**HIGH TECH CORRIDOR DEVELOPMENT, LLC
HARRISON COUNTY, WEST VIRGINIA**

WHITE OAKS PASE II A

ADDENDUM #2

THRASHER PROJECT #T30-11114

STORMWATER BASIN (A-A) PROFILE

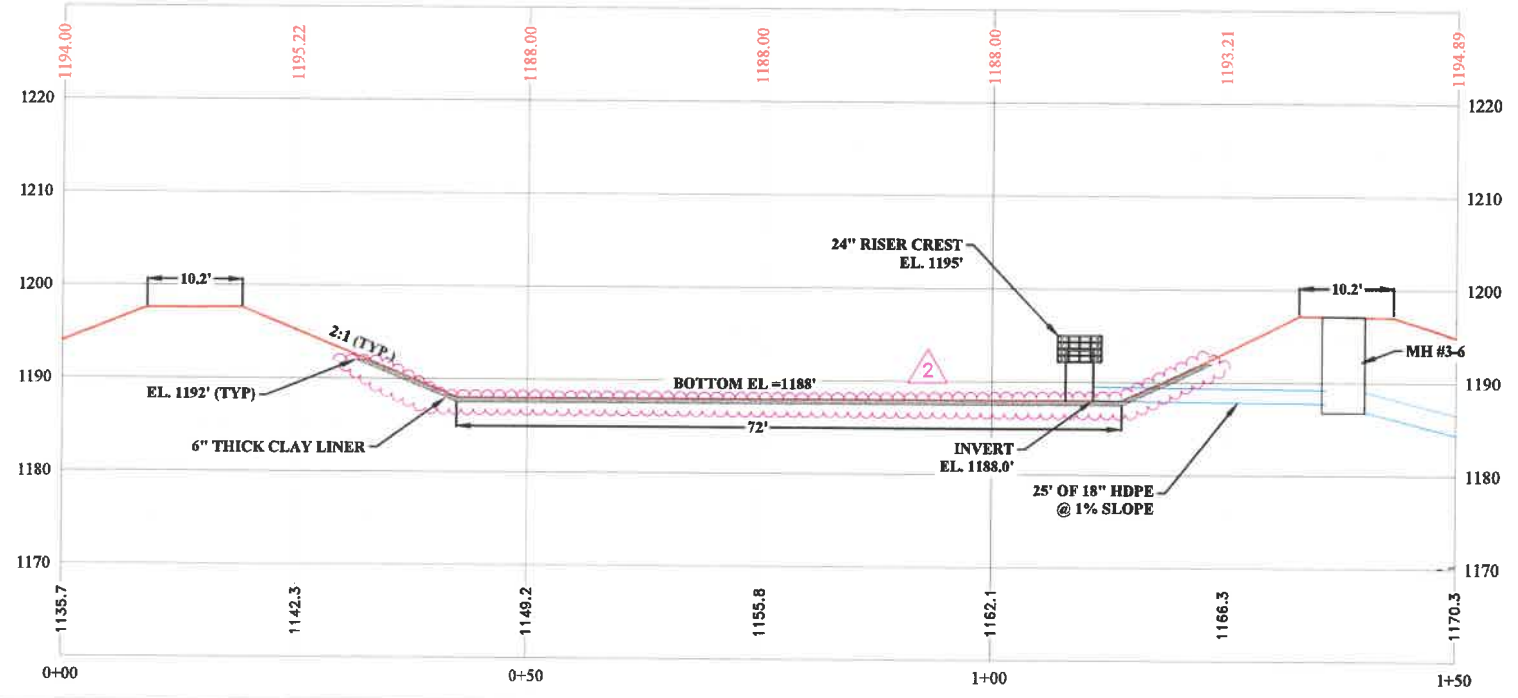
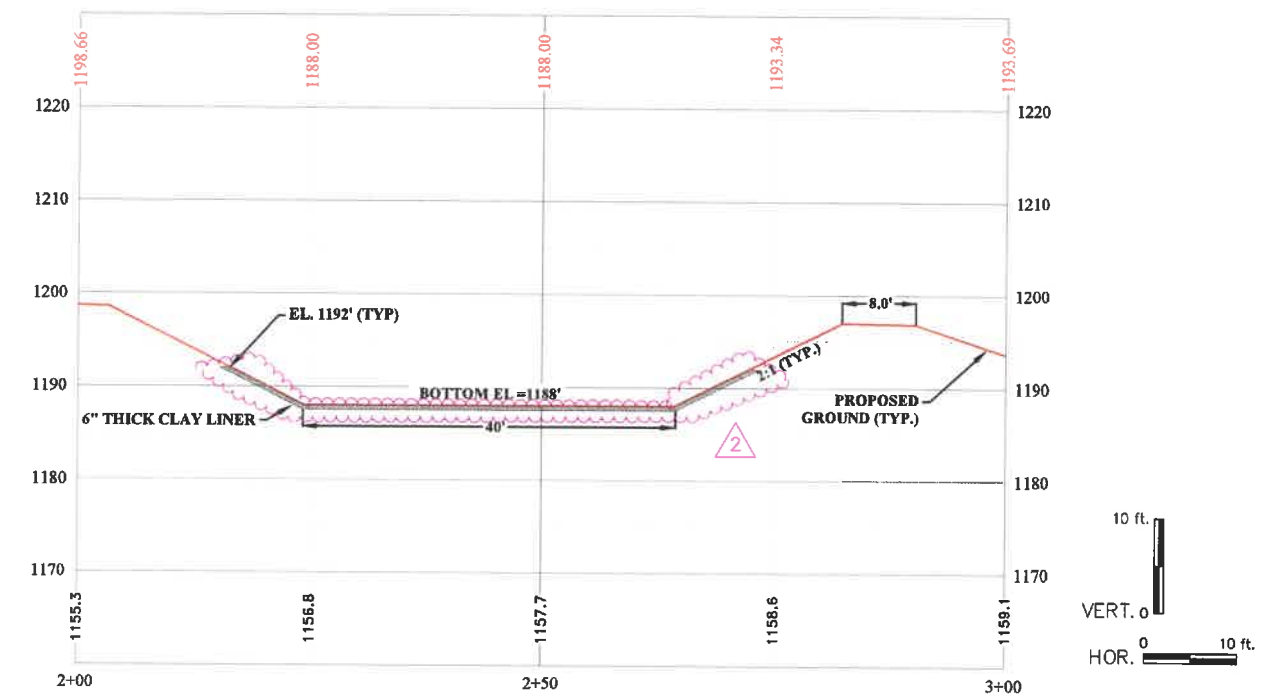
Is the 18" pipe outlet from the stormwater basin paid as part of the basin bid item or the 18" pipe item?

The discharge pipe is incidental to the Stormwater Basin Bid Item.

SHEET No.
30

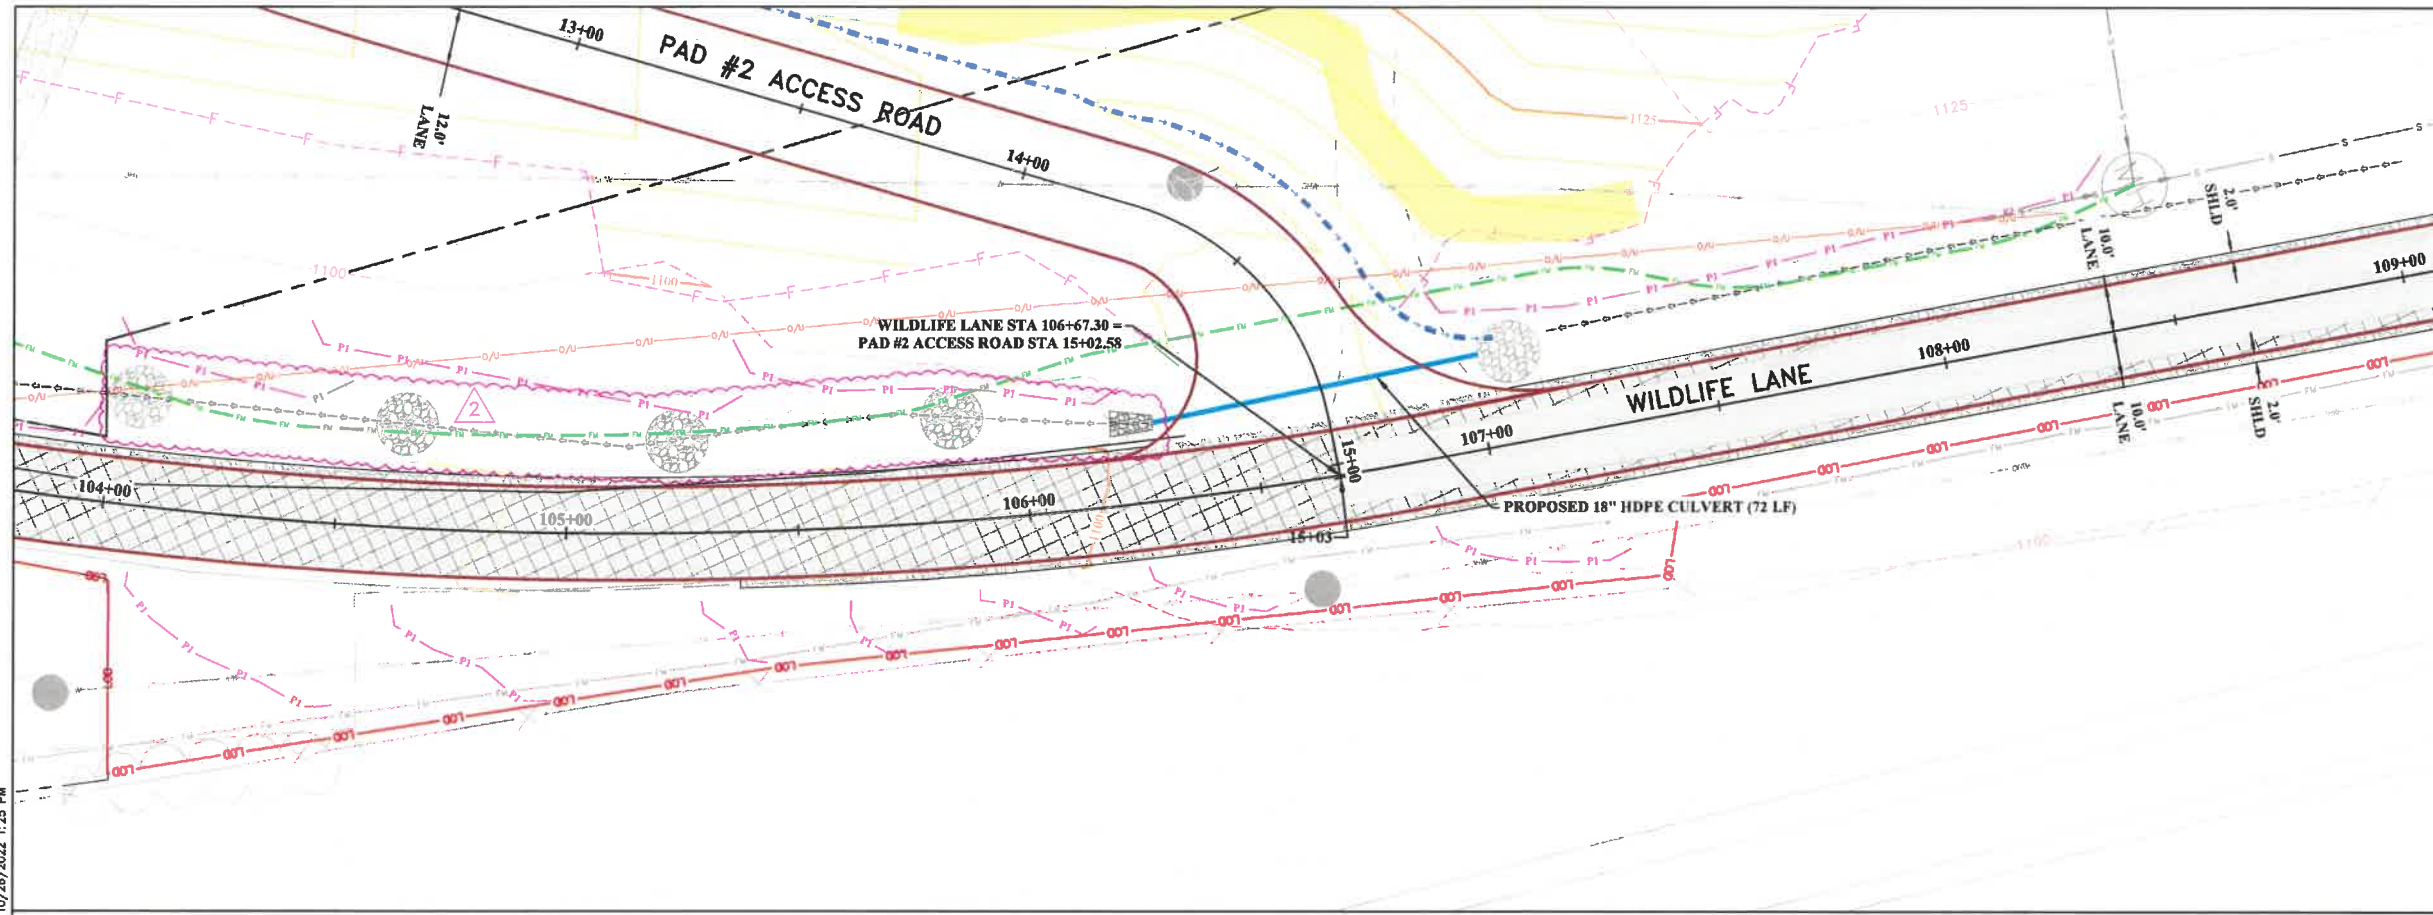
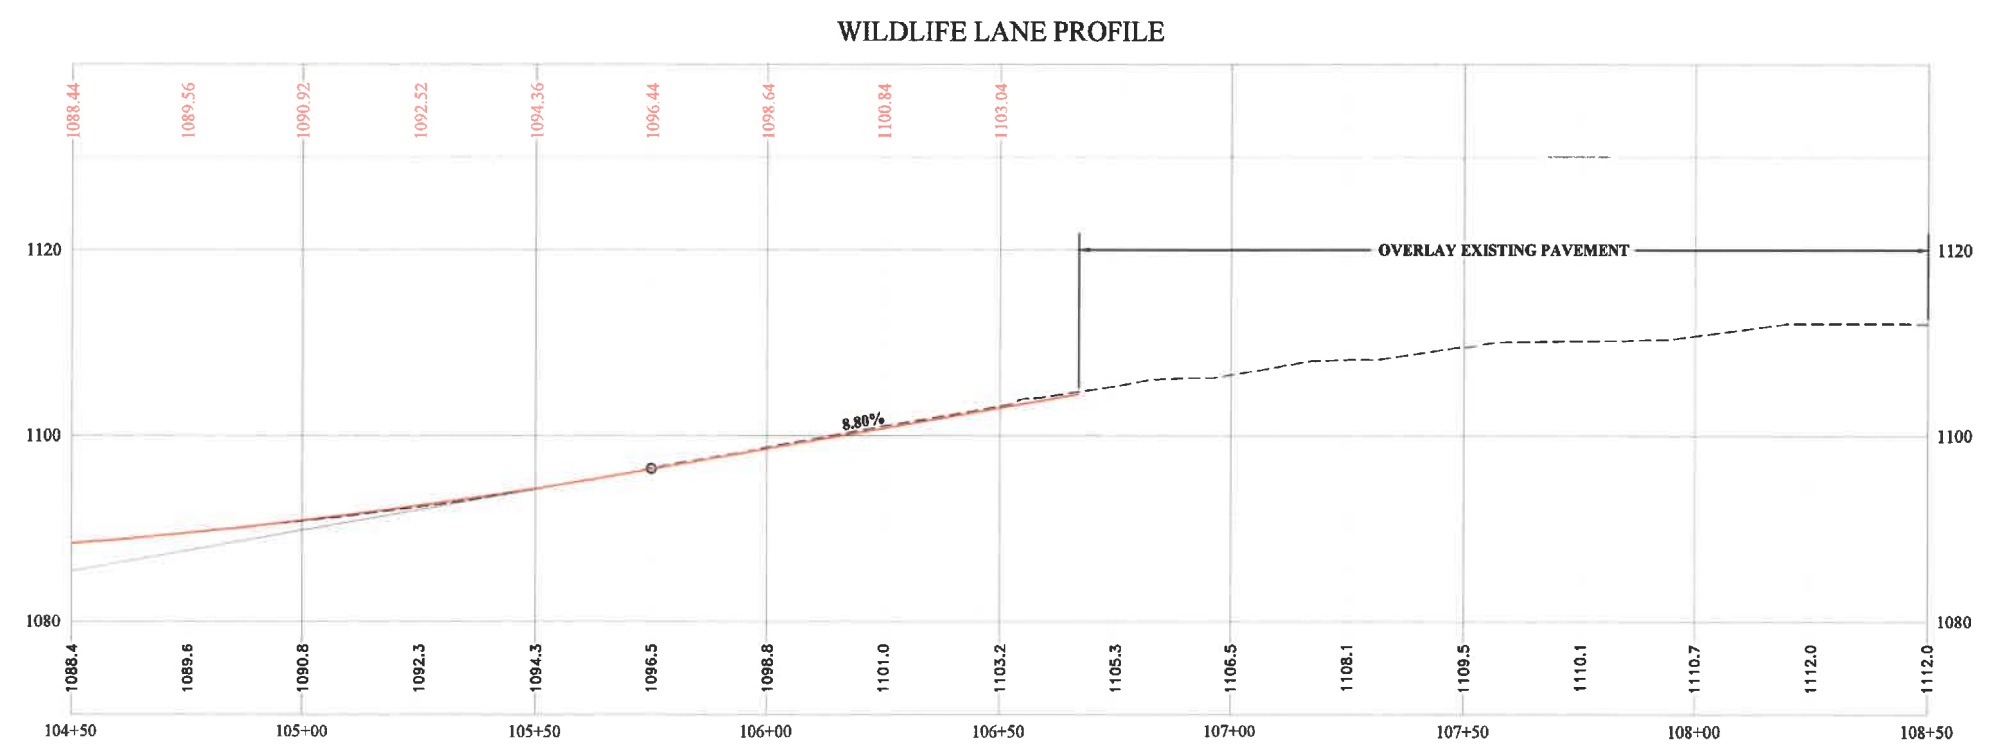
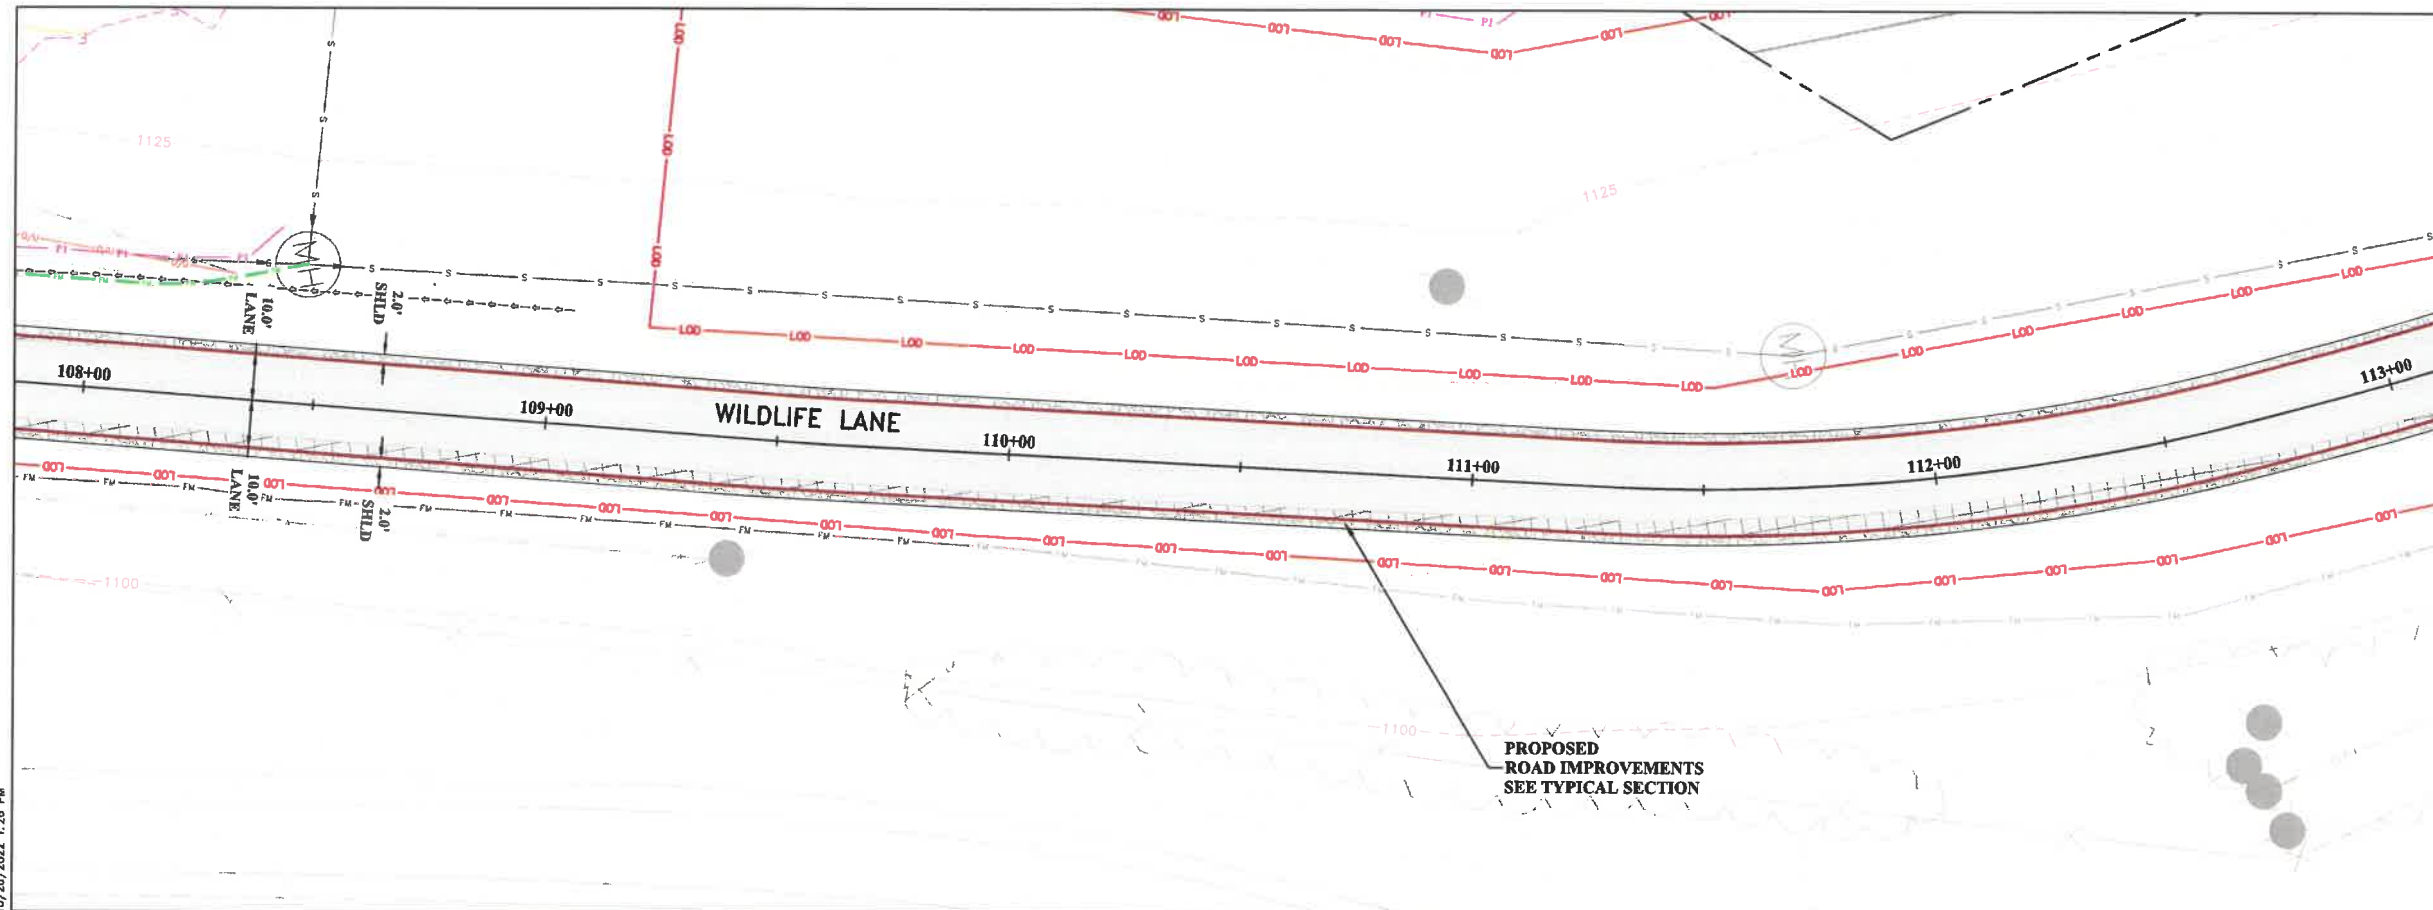
Referring to plan sheets 30 and 31, is the intent to perform the full depth pavement to the dark red line, or beyond that line to the limits of the cross-hatching?

The intent is to perform the full depth pavement to the dark red line and not beyond. The plan sheets have been revised to reflect this.
